Ref: 170095 -CV-LE01-1

**Re: – 17-23 Talavera Road Macquarie Park - Realignment of Drainage Easement**

Attachment: Drawing SK100 Rev 4 Ø1800 Stormwater Trunk Main Realignment Options

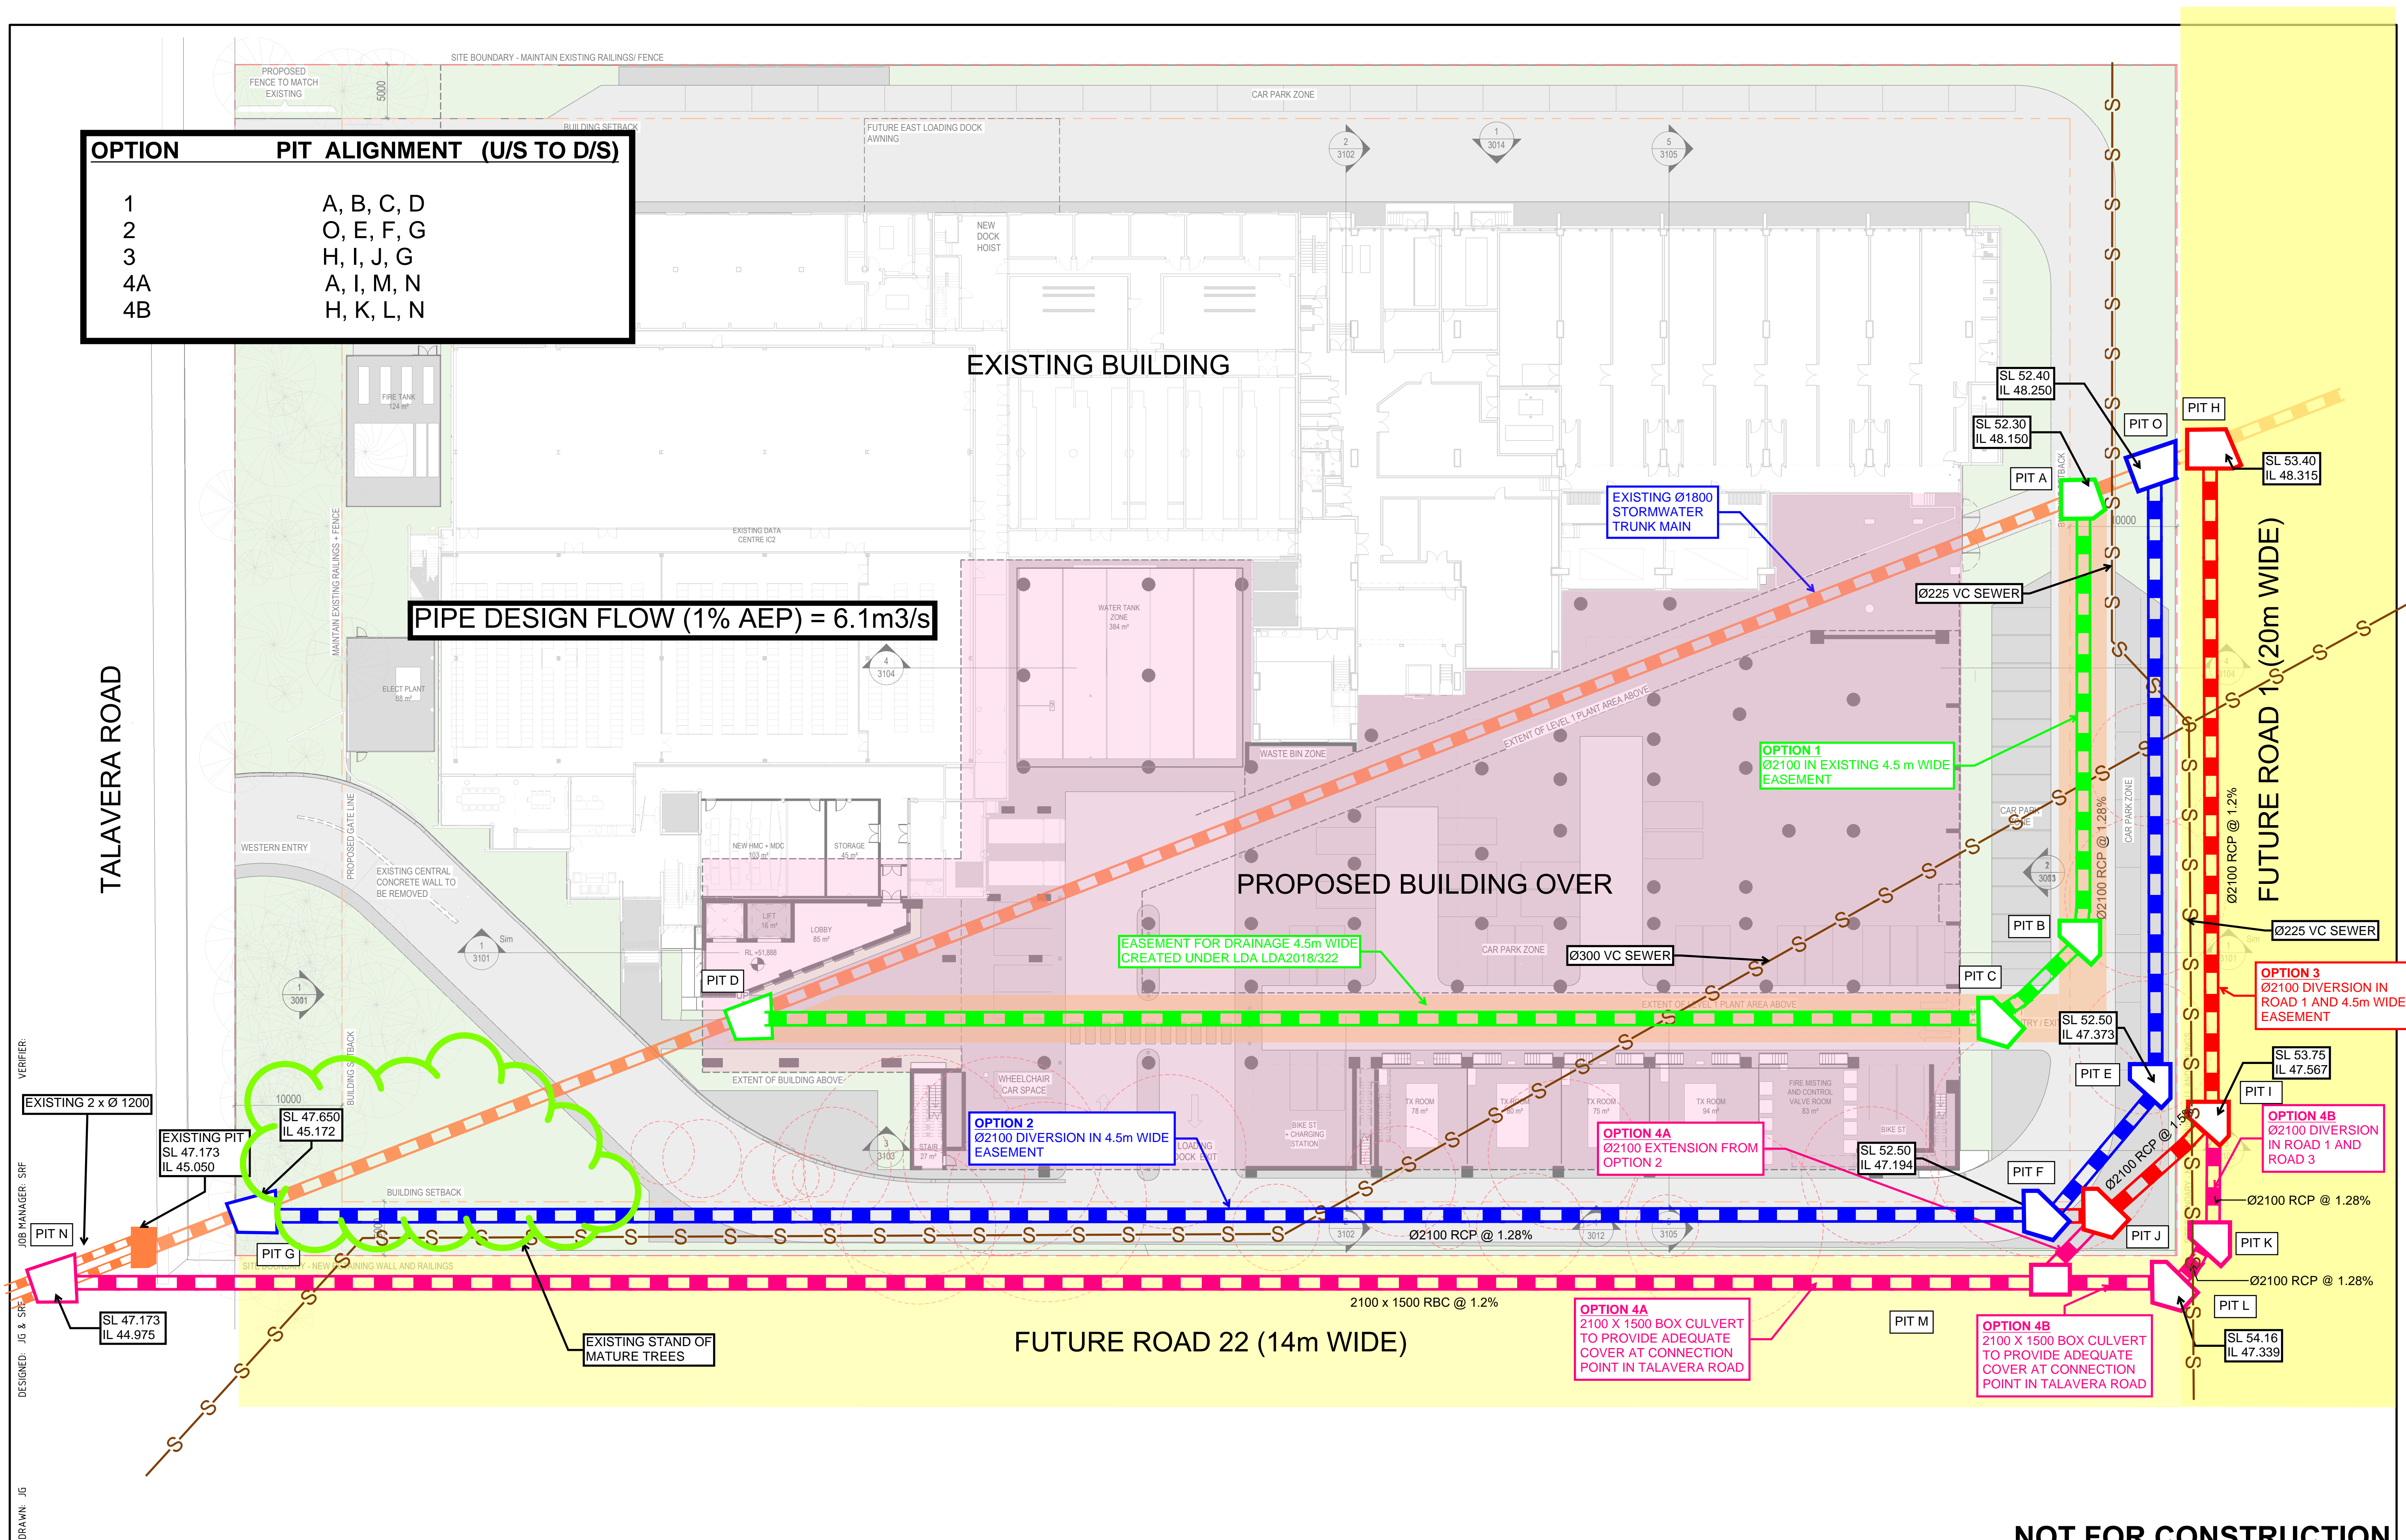
Option 1 which follows the alignment of an easement for drainage, benefiting Council, created in response to a development consent condition for LDA/2018/0322, will fall within the undercroft area of the proposed building. Council have stated they are not supportive of this outcome, leaving Options 2, 3, 4A and 4B as alternative alignments.

Council requested a modification to the Option 2 alignment which accommodates future works within upstream sites. Option 2 as described on the attached drawing presents the alignment meeting Council's request. Feasibility, of this alignment is still subject to review of impacts caused by existing in ground services.

Council were generally in agreeance that each of the options were feasible form a hydraulic and flooding viewpoint. However, Option 3, 4A and 4B options are reliant on the future road network being dedicated to Council subject to coordination with existing services, in particular the Sydney Water sewer.

The future roadways offer a desirable outcome for Council as it allows Council infrastructure to be located wholly outside of private land.

Further consultation with Council is required as both planning and commercial matters in addition to engineering matters need to be considered before final agreement can be reached.
